Intel[®] I/O Controller Hub 10 (ICH10) Family

Specification Update

| Document Number: 319974-008

Figure 2-1 Intel® ICH10 Interface Signals Block Diagram

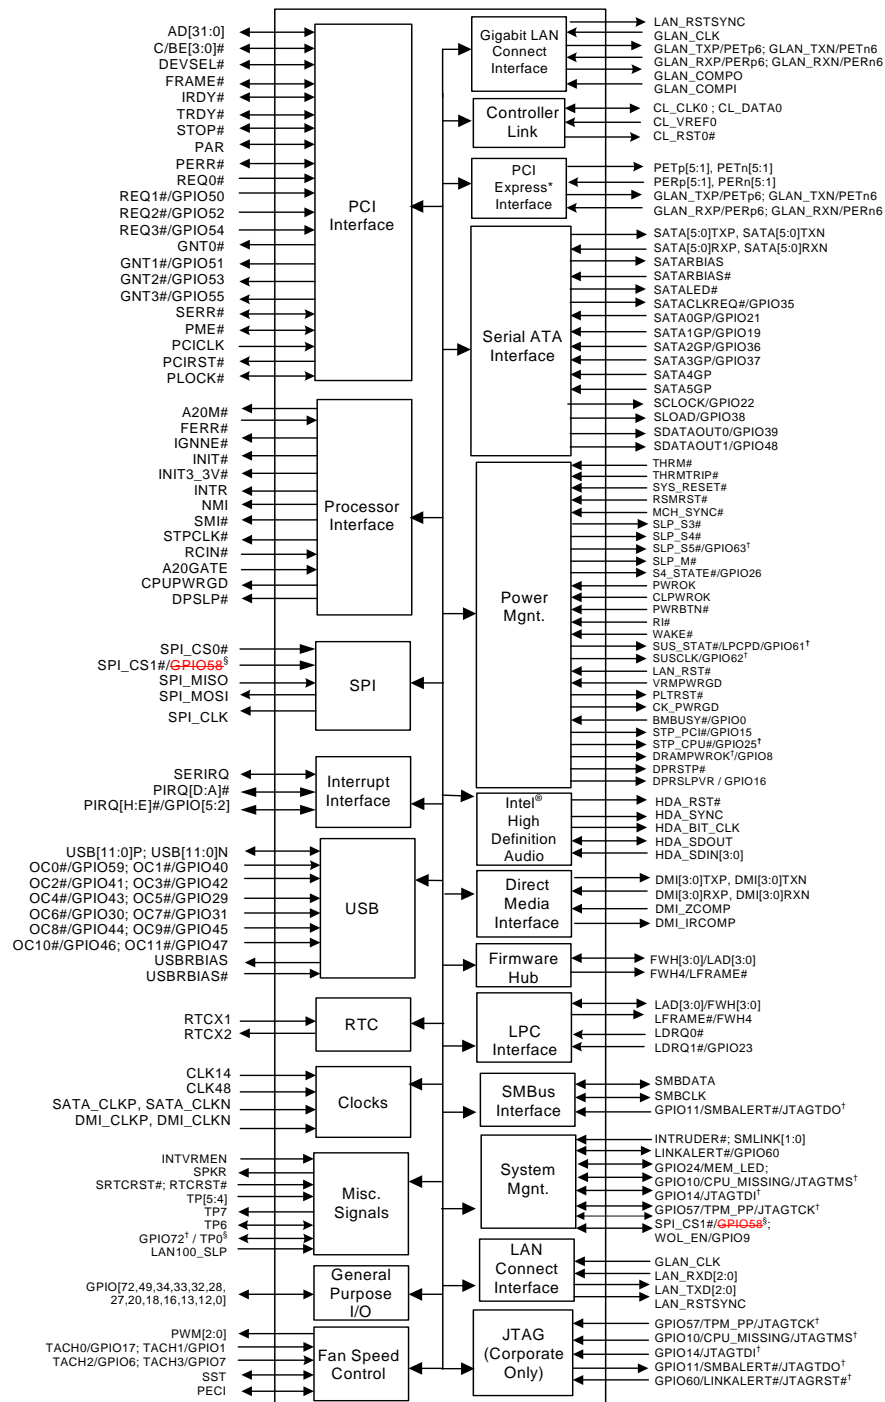
9. Remove GPIO58 from Figure 2-1 Intel® ICH10 Interface Signals Block Diagram

Update the following block diagram in Section 2 Signal Description in the Datasheet.
